Part 3A Revised Concept Plan and Project Application for Graythwaite (ref MP – 0149 and MP – 0150)

GRAITHWAITE PART 3A REVISED CONCEPT PLAN AND PROJECT APPLICATION
(Reference MP – 0149 and MP – 0150)

SUBMISSION TO THE NSW DEPARTMENT OF PLANNING

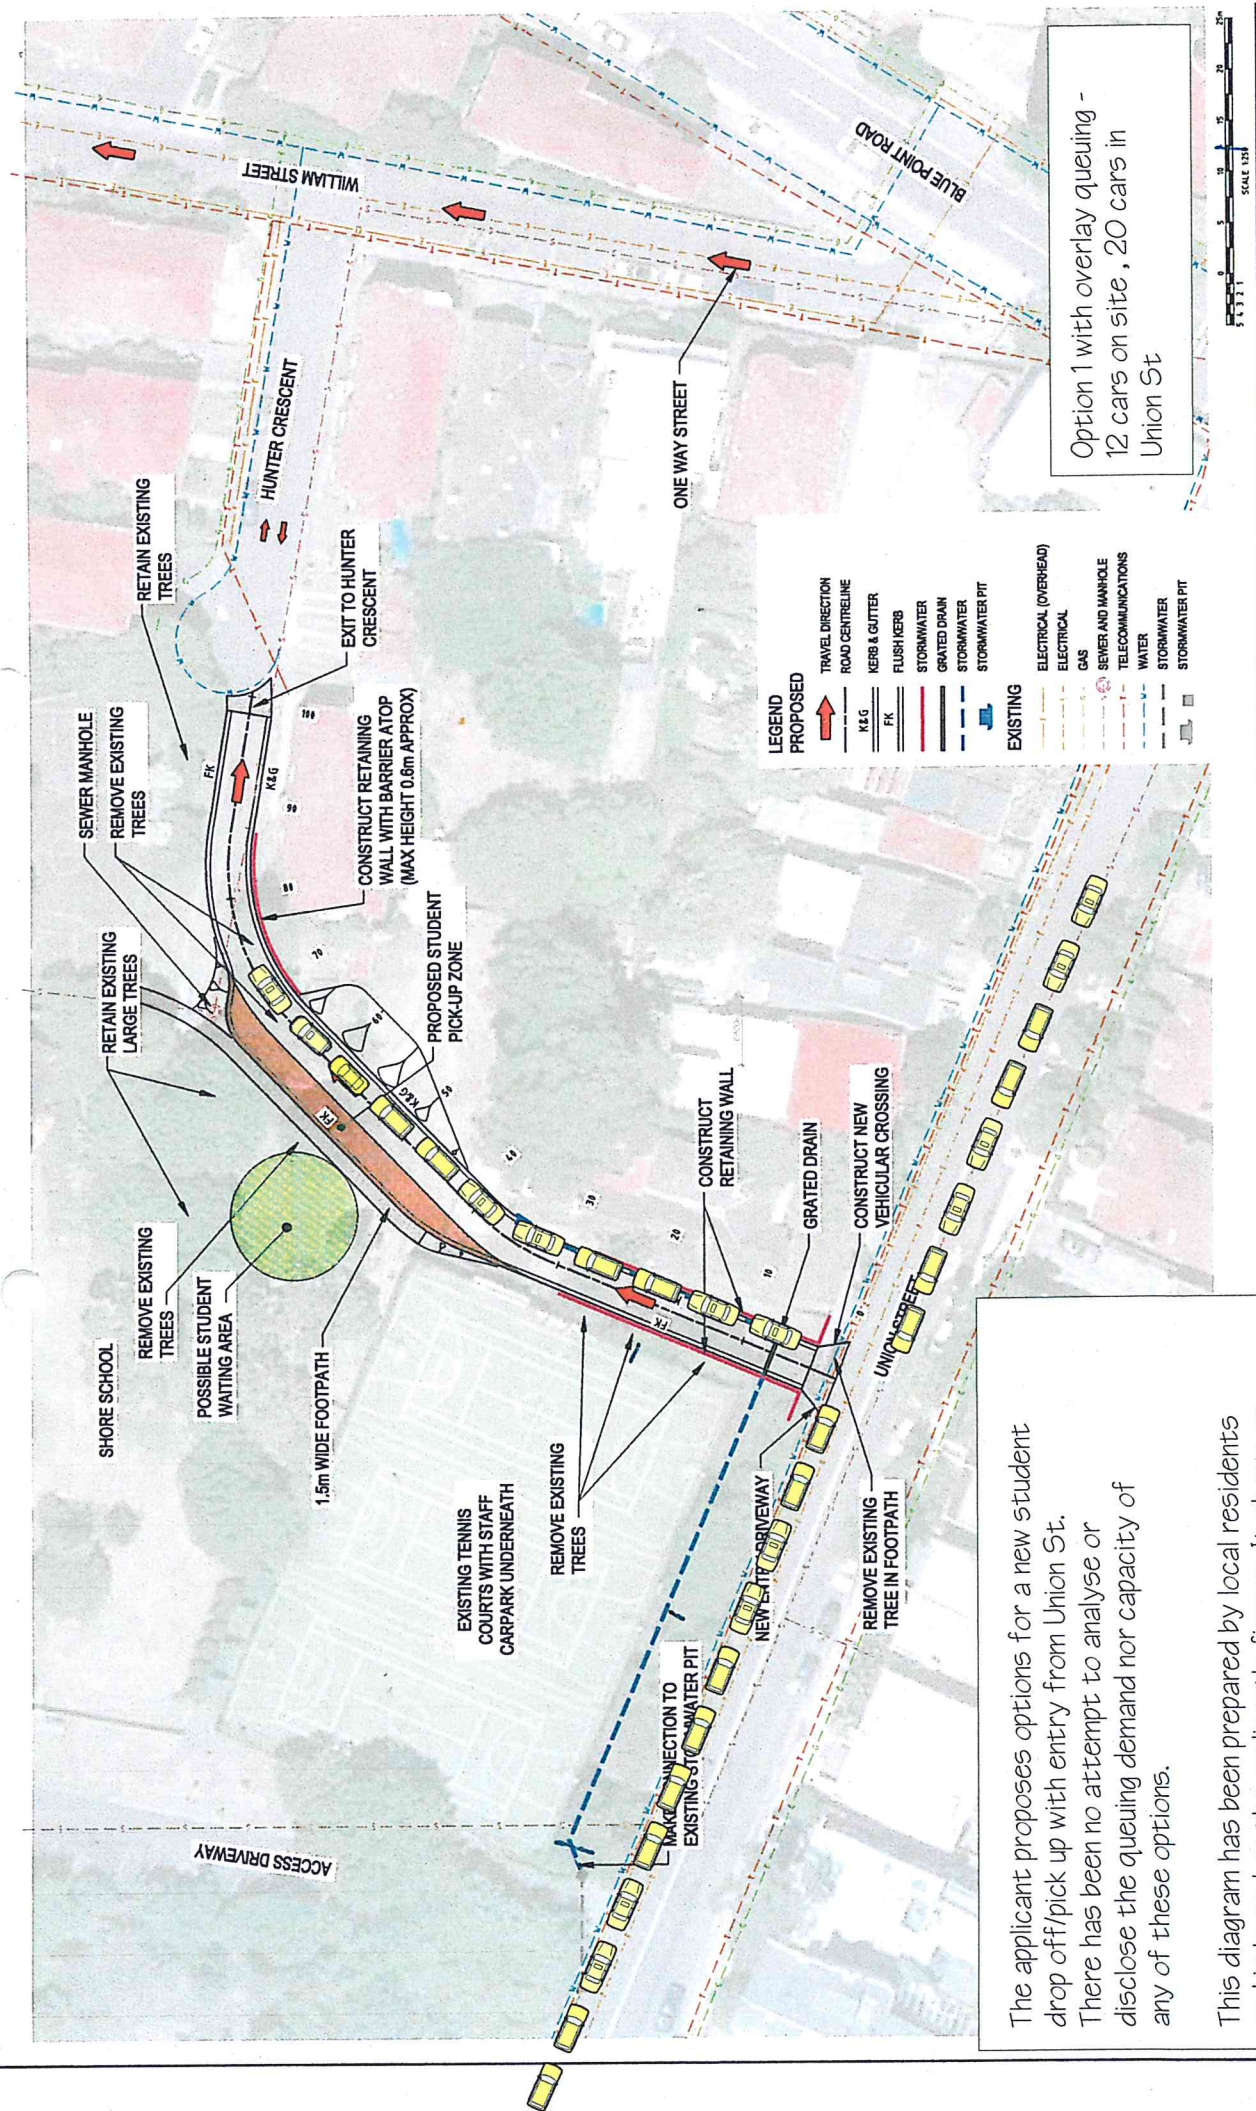
GREEN line

Potential under cover pick-up in Centenary car park using Blue St and William Sts as feeders. Any external queuing is on local roads, not collector roads.

BLACK dotted line

Potential additional pick up using existing playing field perimeters, as currently used by Shore on special occasions

OPTION 1 NEW ENTRY DRIVEWAY OFF UNION STREET

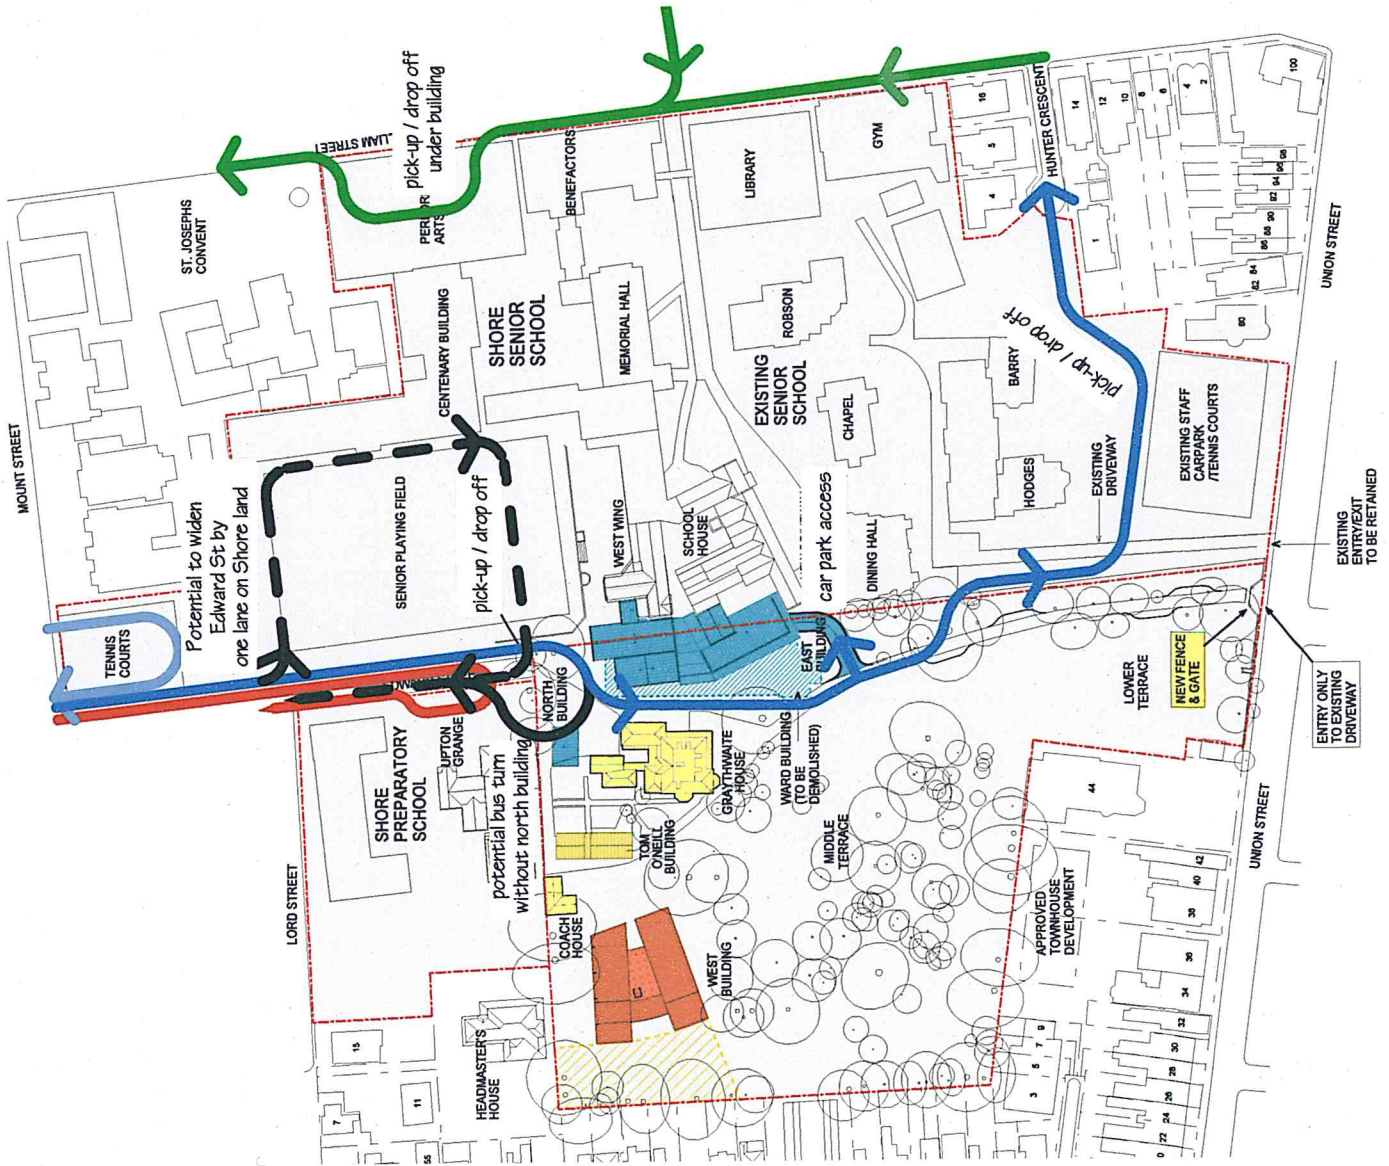
The queuing cars will spill out onto Union Street, as illustrated on the plan at **Attachment B**. This plan clearly shows that Union Street will become impassable, with the eastbound lane blocked by vehicles trying to turn left into the site and the westbound lane blocked as vehicles turning right. The vehicles slowed or queuing to turning left will effectively block the Graythwaite driveway immediately adjoining to the east, and prevent that driveway from operating.

The applicant proposes options for a new student drop off/pick up with entry from Union St. There has been no attempt to analyse or disclose the queuing demand nor capacity of any of these options.

This diagram has been prepared by local residents and is based on the applicant's figures. It shows an afternoon queuing demand of 32 cars for the 15 minute period leading up to pick up time. This Option 1, has onsite capacity for only 12 cars!
